From: Dale Branch
Sent: 11/04/2023 8:35:19 PM
To: Council Northernbeaches Mailbox
Cc: Steve Branch; Janelle Branch
Subject: TRIMMED: Supplementary Submission in relation to DA2022 / 0145
Attachments: 816 Pittwater Road_Supplementary Submission.pdf;

RE: Supplementary Submission – DA2022/0145 – 4 Delmar Parade and 812 Pittwater Road, Dee Why

This supplementary submission has been prepared in relation to DA2022/0145 (the application) at 4 Delmar Parade and 812 Pittwater Road, Dee Why (the site). It has been prepared on behalf of the owners of the adjacent lot to the north and west of the site at 816 Pittwater Road (see **Figure 1**). DA2022/0145, as amended since lodgement, seeks approval for demolition works and the construction of a mixed-use development comprising a five and seven storey residential building above two common basement levels (the Proposal).

Figure 2 North-facing Apartments in Building B (Plan TP05.01 D – 12:00pm shadow analysis) – annotation added in blue
Source: Rothelowman (Dated 27.3.23 on Council DA Tracker “Plans-Master Set – Amended”)

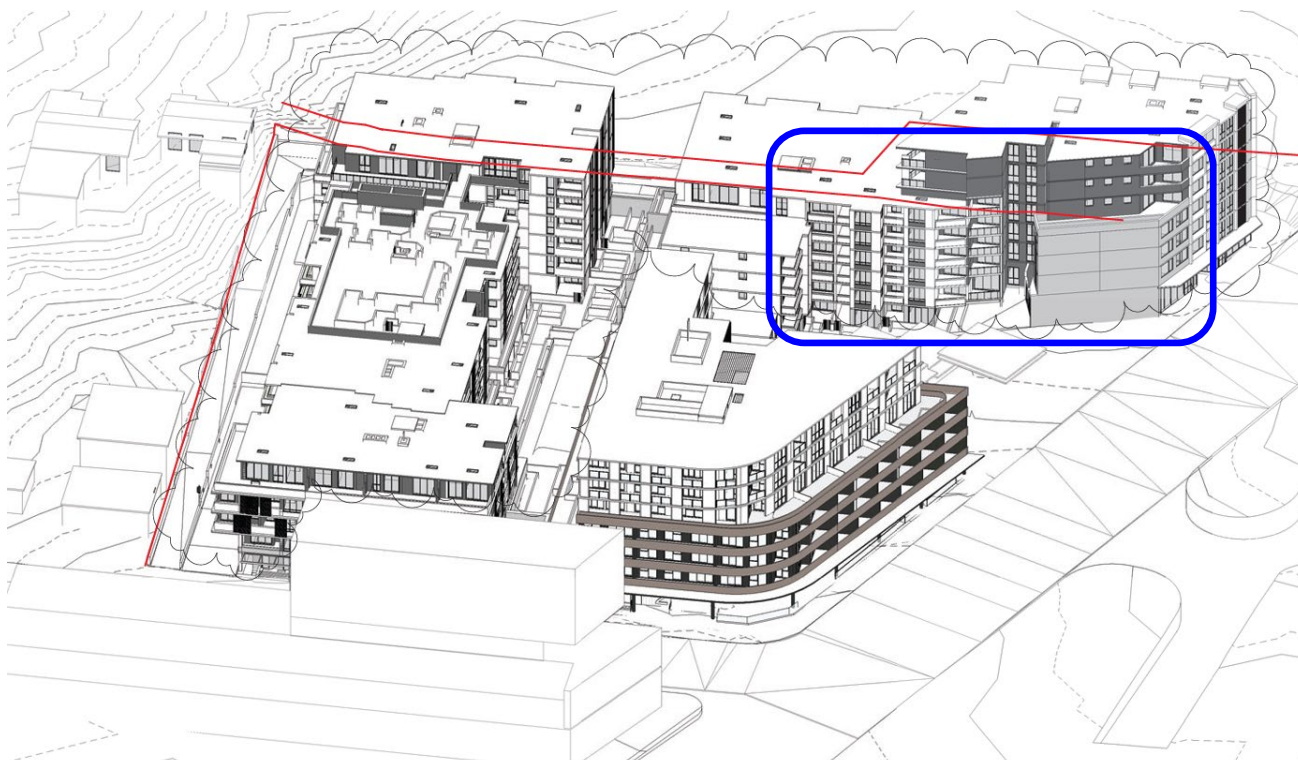
The ADG requires that living rooms and private open spaces of at least 70% of apartments in a building receive a minimum of 2 hours of direct sunlight between 9 am and 3 pm at mid-winter. As commented in the SEPP 65 Statement that accompanies the application, the Proposal suggests that exactly 70% of proposed apartments receive the required two hours of solar access to living room windows and private open space. Of these compliant apartments, it is understood that approximately seven north-facing apartments per level in building B rely on 816 Pittwater Road remaining undeveloped to achieve compliance (see **Figure 2**). No detailed breakdown, or diagrams have been provided with the application to confirm the validity of the suggested compliance.

Consequently, any development of 816 Pittwater Road would result in the Proposal no longer achieving compliance with the ADG on the measure of solar access, aside from privacy. This is evident in **Figure 3**, which provides an outline of the allowable built form at 816 Pittwater Road (24m height and 3.2:1 FSR).

Figure 3 Solar Access to Building B with 816 Pittwater Road Developed to its Planning Controls

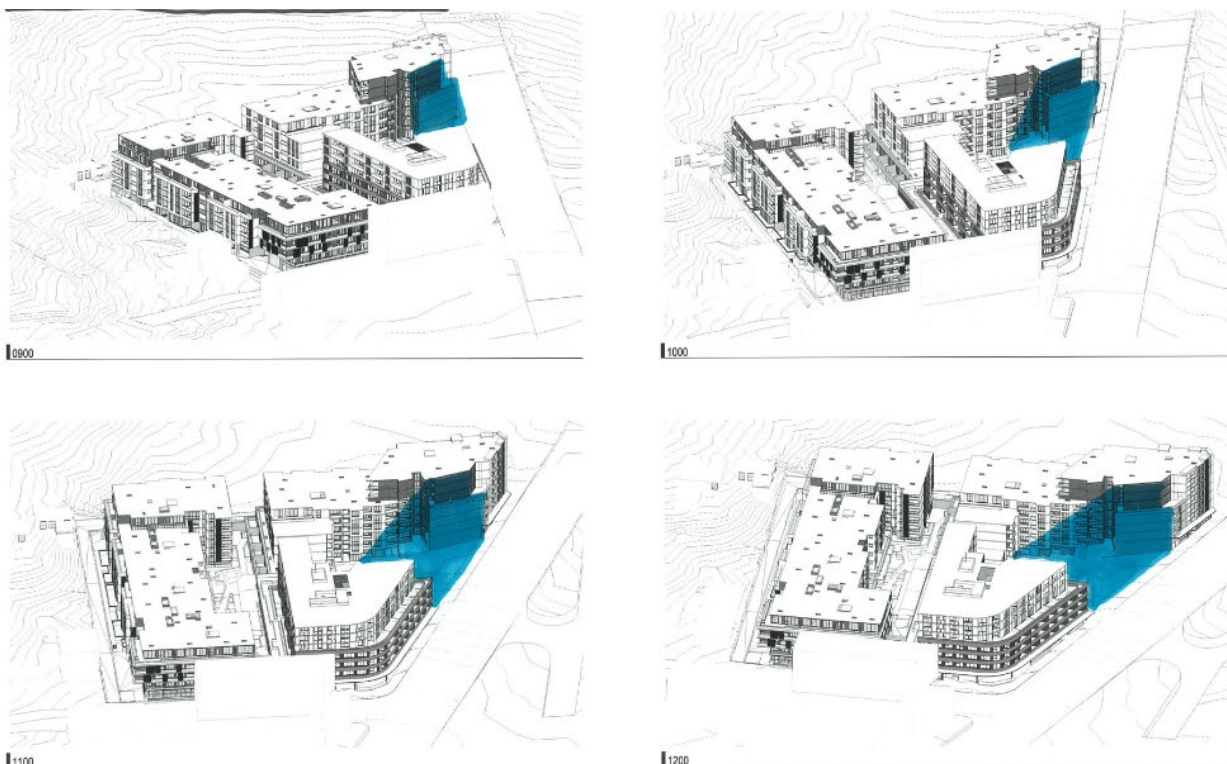
As mentioned above, the Proposal’s impact on the developability of 816 Pittwater Road is a relevant consideration as well as the impact of a future development on the site. As established in *The Benevolent Society v Waverley Council* [2010] NSWLEC 1082 (previously the *Parsonage v Ku-ring-gai* planning principle), “in areas undergoing change, the impact on what is likely to be built on adjoining sites should be considered when assessing the adequacy of solar access”. It is apparent that this has not been given any regard.

As with the proposed building separation and provision of suitable setbacks to enable areas in transition, the impacts of overshadowing to the Proposal have not been appropriately considered and set up a substandard planning outcome for both No 812 and the future development of 816 Pittwater Road.

Figure 4 Proposed Building Separation – Level 5 of Building B

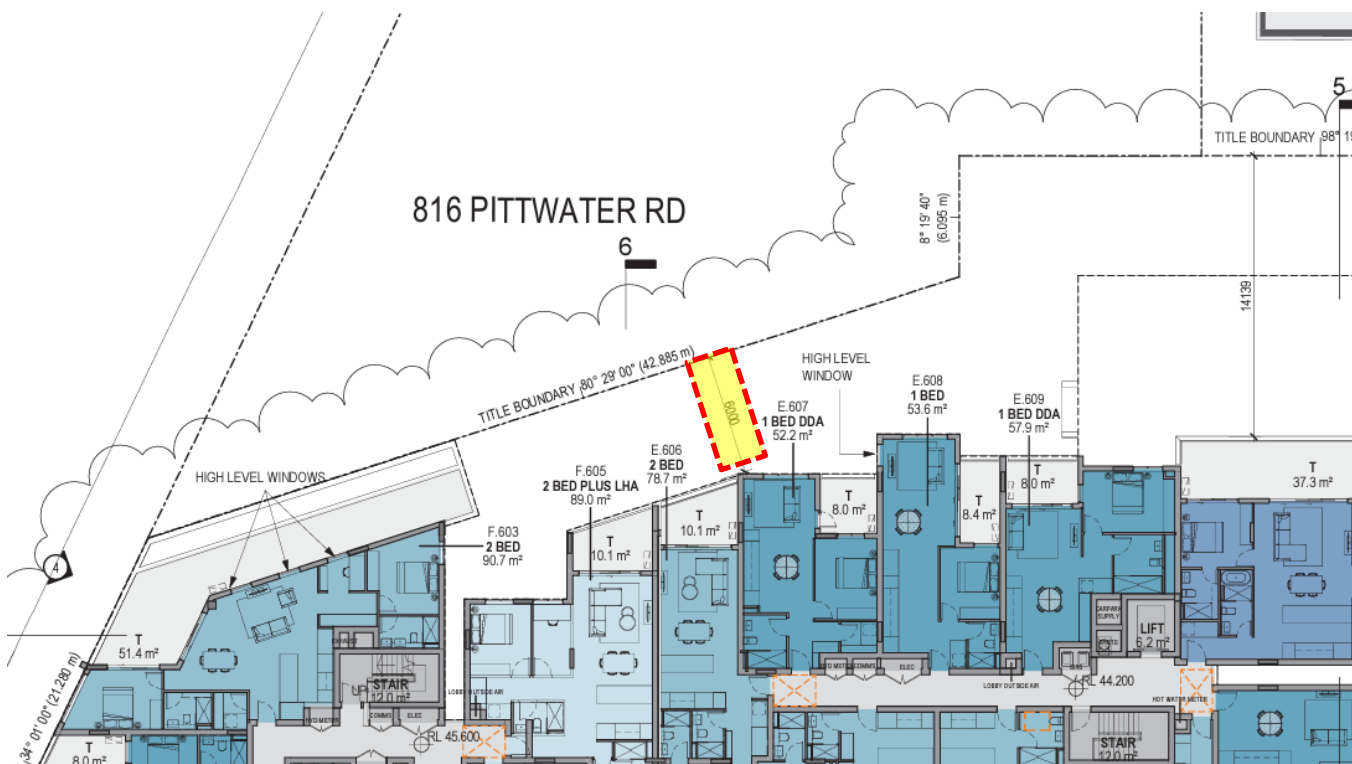
The ADG requires a minimum 6m separation between residential buildings to side boundaries for up to four storeys and 9m for levels 5 to 8 (assuming between non-habitable rooms). Furthermore, the minimum separation between residential buildings is 12m between habitable rooms and balconies for up to four storeys and 18m for levels 5 to 8. As shown in the below extract, the Proposal provides a 3.3m and 6m setback (with windows and balconies) between habitable north-facing balconies of levels 5 to 7 and the shared boundary with 816 Pittwater Road.

In order to comply with the ADG, the north-facing dwellings in Building B would need to be set back by a minimum of **9m** or reorientated to face east (parallel with the northern boundary alignment) rather than north to achieve compliance with the ADG and provide for the orderly and economic development of 816 Pittwater Road. Without doing so, a poor planning outcome would be foreshadowed, placing an unreasonable burden on any future redevelopment of 816 Pittwater Road to provide excessive and onerous building setbacks to achieve required building separation distances. As shown in **Figure 5** below, approximately three apartment units would be lost on each level for a residential flat building developed at 816 Pittwater Road due to these onerous building setbacks.

Figure 5 Undevelopable Portions (Highlighted Yellow) of 816 Pittwater Road due the Proposal’s ADG Building Separation Non-compliances

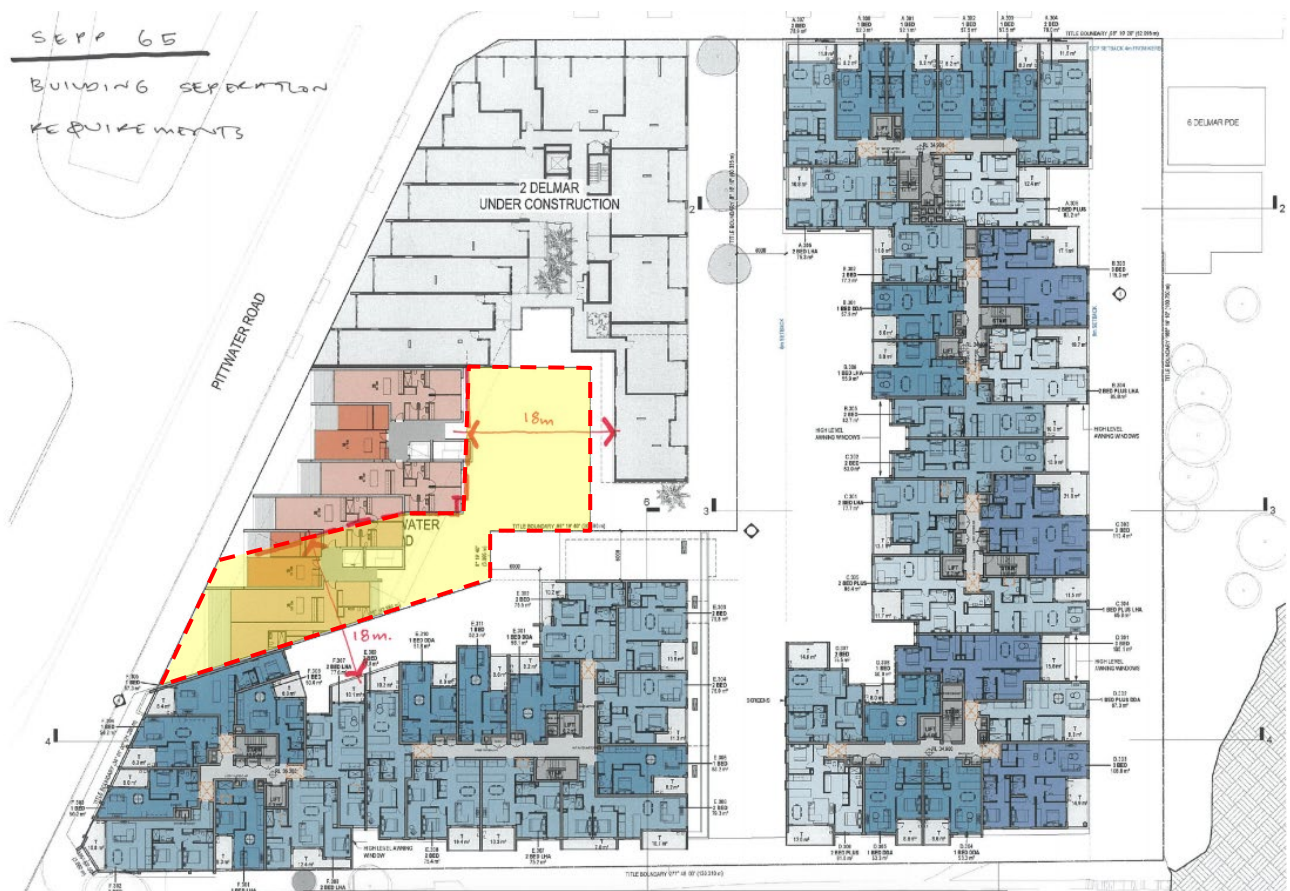
Source: Base image: Rothelowman, markup of compliant separation in yellow. Indicative layout required to respond to proposed development shown on 816 Pittwater Road.

Again, this inhibits the orderly and economic use and development of 816 Pittwater Road. Compounded by the approval of the previous DA at No 2 Delmar Pde, the theoretical building envelope of 816 Pittwater Road would be unreasonably and unnecessarily curtailed, as a direct result of a poor design outcome and lack of response to site constraints (including likely future development) in the current DA.

Figure 2 North-facing Apartments in Building B

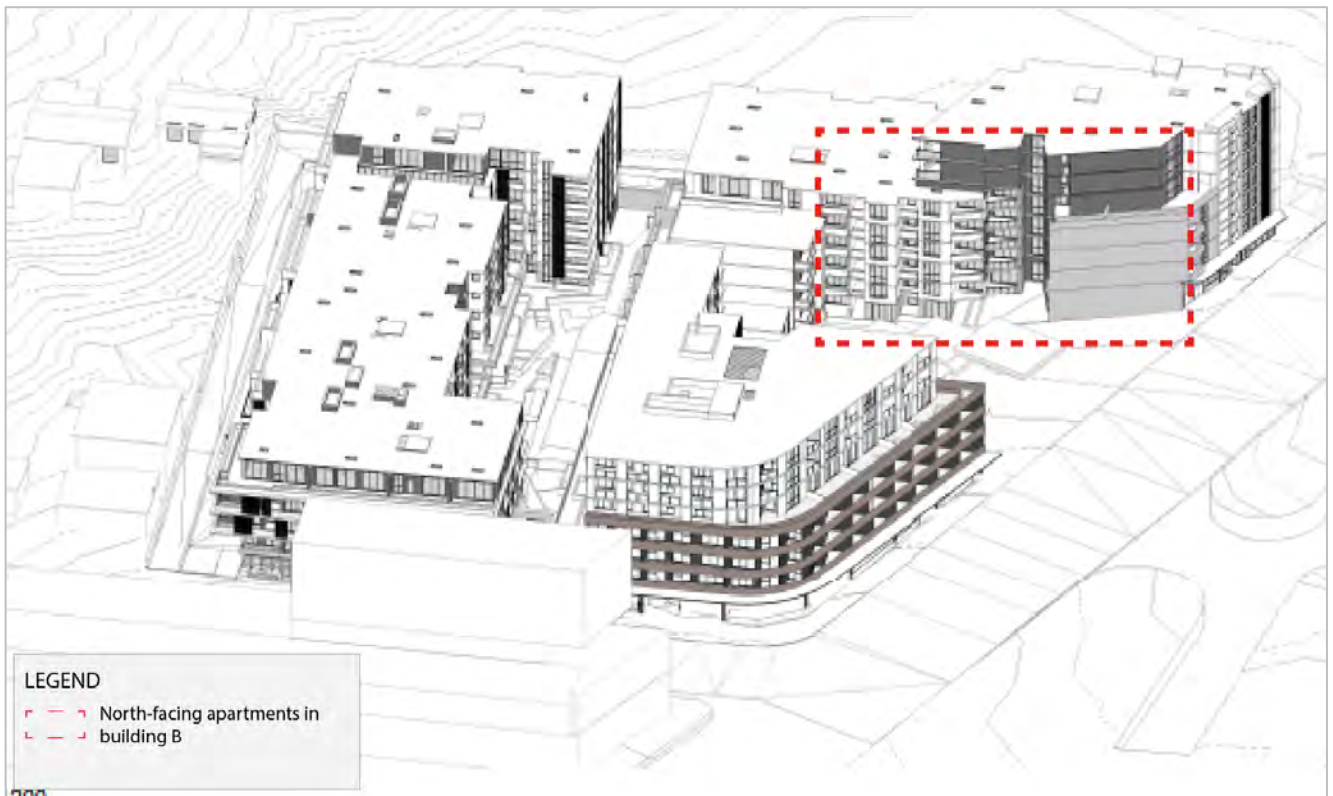
The ADG requires that living rooms and private open spaces of at least 70% of apartments in a building receive a minimum of 2 hours of direct sunlight between 9 am and 3 pm at mid-winter. As commented in the SEPP 65 Statement that accompanies the application, the Proposal suggests that exactly 70% of proposed apartments receive the required two hours of solar access to living room windows and private open space. Of these compliant apartments, it is understood that approximately seven north-facing apartments per level in building B rely on 816 Pittwater Road remaining undeveloped to achieve compliance (see **Figure 2**). No detailed breakdown, or diagrams have been provided with the application to confirm the validity of the suggested compliance.

Consequently, any development of 816 Pittwater Road would result in the Proposal no longer achieving compliance with the ADG on the measure of solar access, aside from privacy. This is evident in **Figure 3**, which provides an outline of the allowable built form at 816 Pittwater Road (24m height and 3.2:1 FSR).

Figure 3 Solar Access to Building B with 816 Pittwater Road Developed to its Planning Controls

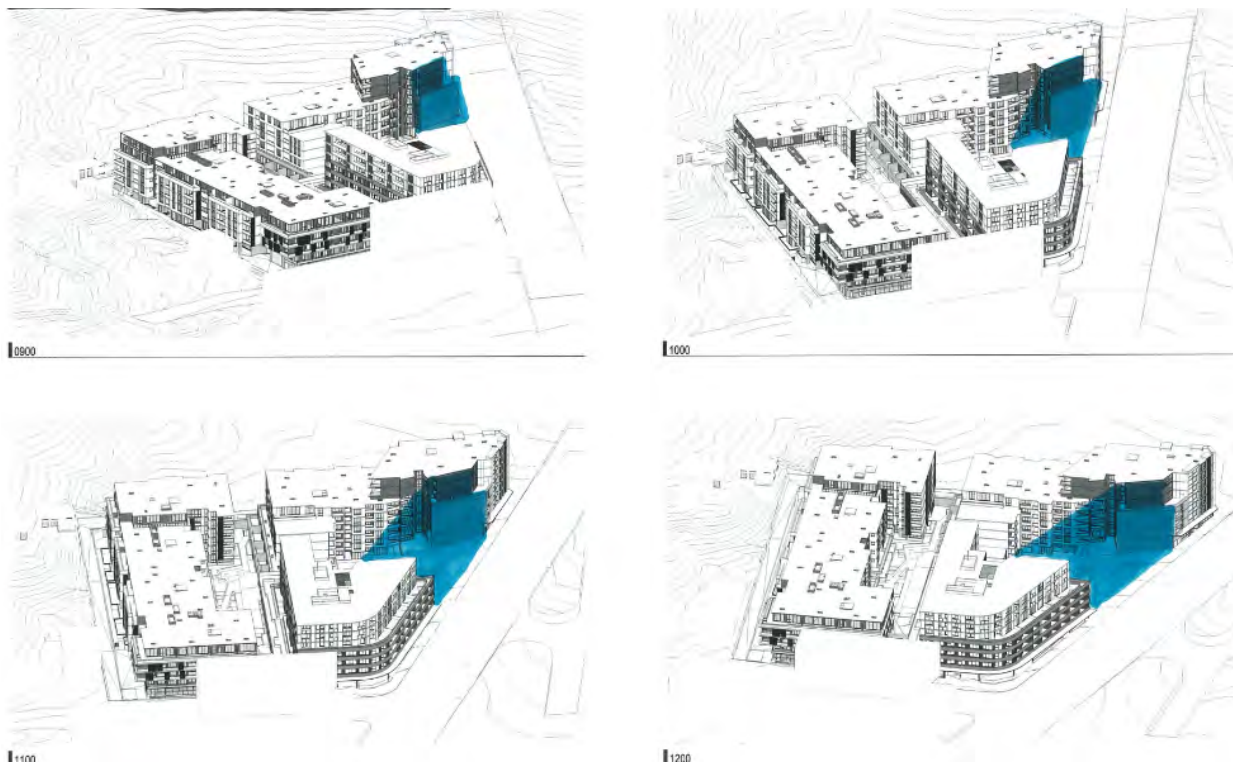
As mentioned above, the Proposal's impact on the developability of 816 Pittwater Road is a relevant consideration as well as the impact of a future development on the site. As established in *The Benevolent Society v Waverley Council* [2010] NSWLEC 1082 (previously the *Parsonage v Ku-ring-gai* planning principle), "in areas undergoing change, the impact on what is likely to be built on adjoining sites should be considered when assessing the adequacy of solar access". It is apparent that this has not been given any regard.

As with the proposed building separation and provision of suitable setbacks to enable areas in transition, the impacts of overshadowing to the Proposal have not been appropriately considered and set up a substandard planning outcome for both No 812 and the future development of 816 Pittwater Road.

Figure 4 Proposed Building Separation – Level 5 of Building B

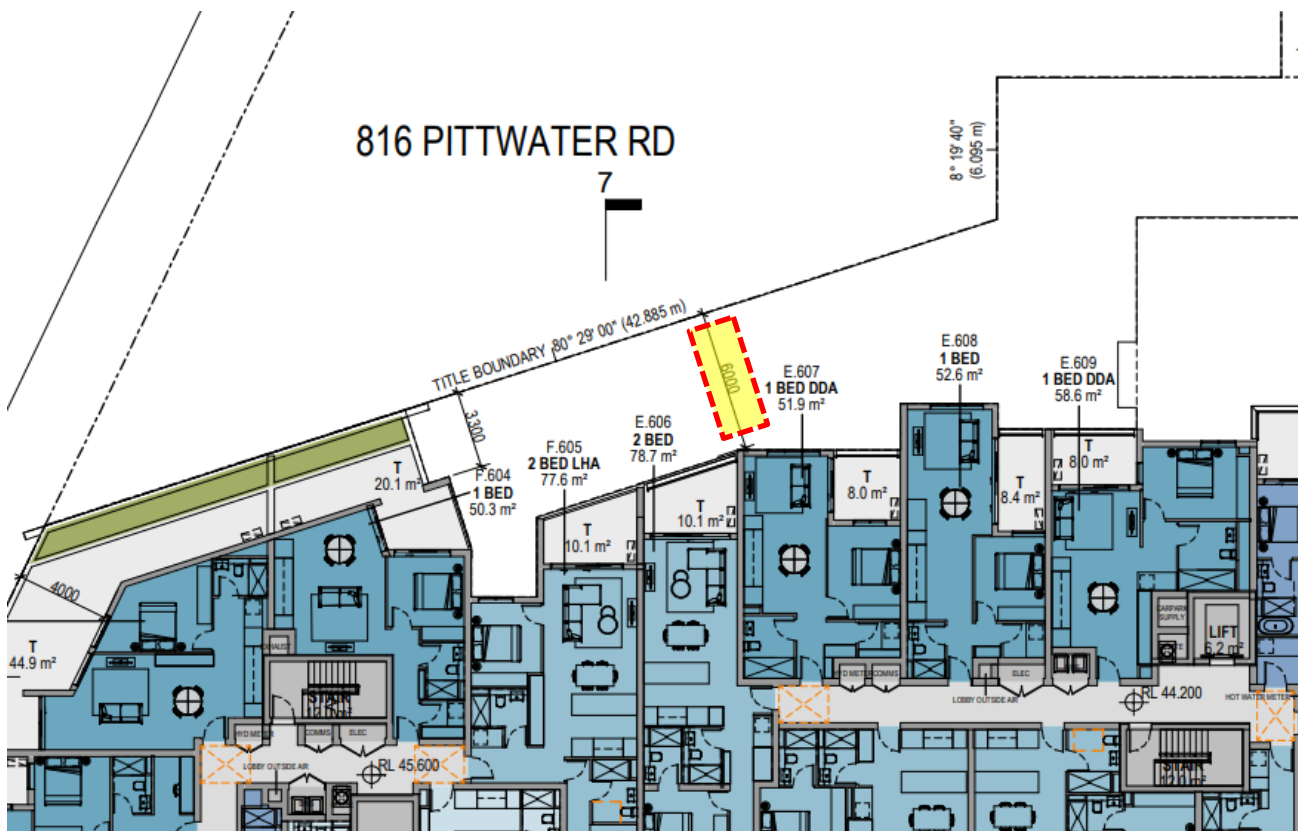
The ADG requires a minimum 6m separation between residential buildings to side boundaries for up to four storeys and 9m for levels 5 to 8 (assuming between non-habitable rooms). Furthermore, the minimum separation between residential buildings is 12m between habitable rooms and balconies for up to four storeys and 18m for levels 5 to 8. As shown in the below extract, the Proposal provides a 3.3m and 6m setback (with windows and balconies) between habitable north-facing balconies of levels 5 to 7 and the shared boundary with 816 Pittwater Road.

In order to comply with the ADG, the north-facing dwellings in Building B would need to be set back by a minimum of 9m or reorientated to face east (parallel with the northern boundary alignment) rather than north to achieve compliance with the ADG and provide for the orderly and economic development of 816 Pittwater Road. Without doing so, a poor planning outcome would be foreshadowed, placing an unreasonable burden on any future redevelopment of 816 Pittwater Road to provide excessive and onerous building setbacks to achieve required building separation distances. As shown in **Figure 5** below, approximately three apartment units would be lost on each level for a residential flat building developed at 816 Pittwater Road due to these onerous building setbacks.

Figure 5 Undevelopable Portions (Highlighted Yellow) of 816 Pittwater Road due the Proposal’s ADG Building Separation Non-compliances

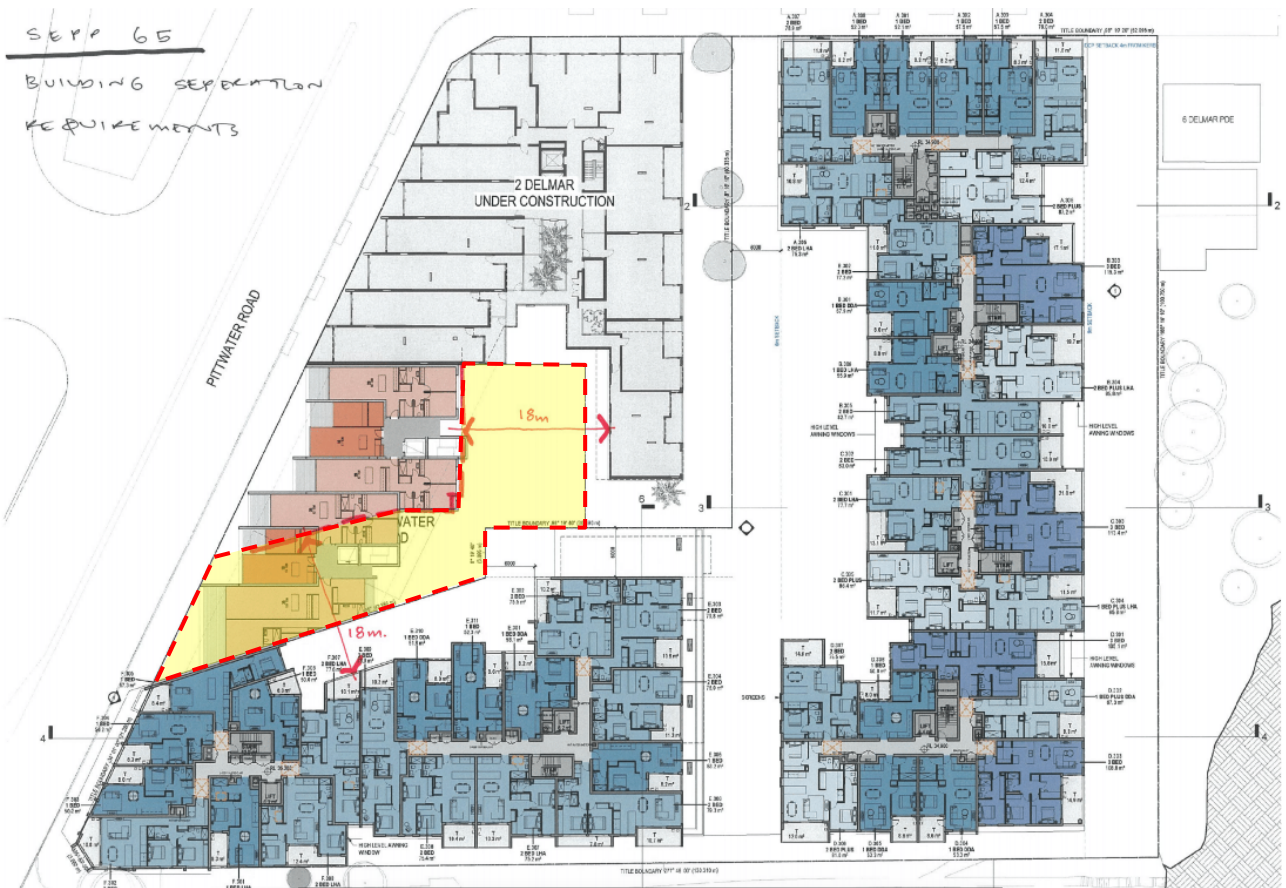
Source: Base image: Rothelowman, markup of compliant separation in yellow. Indicative layout required to respond to proposed development shown on 816 Pittwater Road.

Again, this inhibits the orderly and economic use and development of 816 Pittwater Road. Compounded by the approval of the previous DA at No 2 Delmar Pde, the theoretical building envelope of 816 Pittwater Road would be unreasonably and unnecessarily curtailed, as a direct result of a poor design outcome and lack of response to site constraints (including likely future development) in the current DA.
